Atwater Kent 55

Silvertone 1822, 1831, 1824, 1830

FIG. 1

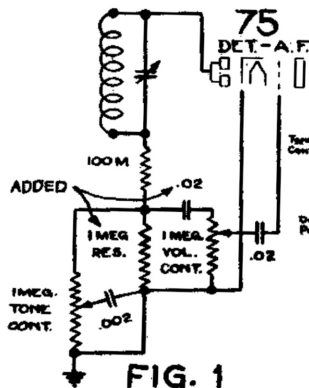
A simple circuit change will correct noisy volume controls. Its effect is to remove the d-c. diode current from the volume control and in practically all cases, it will be found that the trouble will be corrected without changing the volume control. However, if the volume control is replaced, the circuit change should be made in addition to prevent noise difficulties.

Connect a 1-megohm resistor across the outer terminals of the tone control, as indicated in Fig. 1, the schematic, and Fig. 2, the wiring diagram.

Unsolder the two leads from the ungrounded outer terminal of the volume control and solder both these leads to one side of a 0.02-mf. condenser. Connect the other side of this condenser to the volume control terminal from which the two leads were removed.

By the addition of a 1-megohm resistor and a 0.02-mf. condenser, as shown in the diagrams above, noisy volume controls are quieted in these Silvertone sets.
